U.S. Patent Application Serial No. 10/807,516
Amendment filed October 20, 2005
Reply to OA dated July 27, 2005

U.S. Application Serial No. 10/807,516
Amendment filed on October 20, 2005
Annotated Sheet Showing Changes

FIG. 9
PRIOR ART

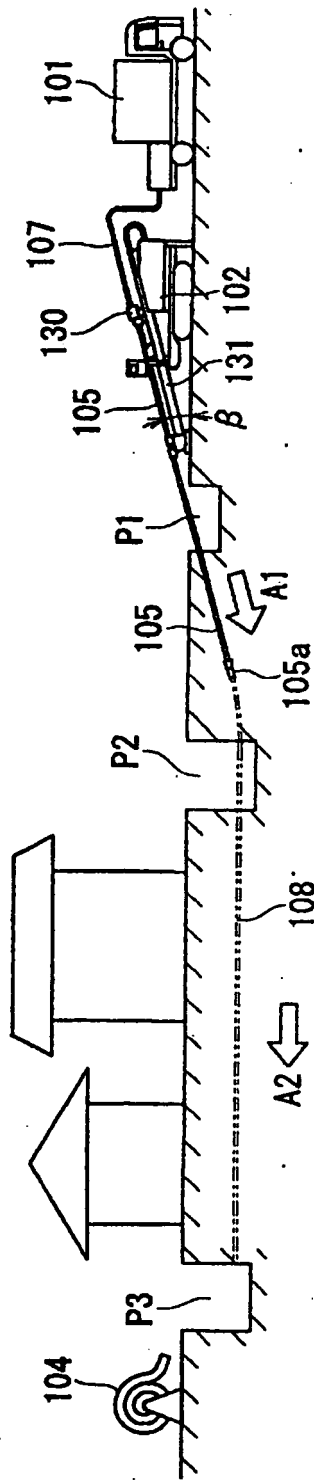
Also, the applicant submits herewith annotated and replacement sheets of drawings indicating that Figs. 9 - 11 illustrate conventional art by having Figs. 9 - 11 labeled as "Prior Art".
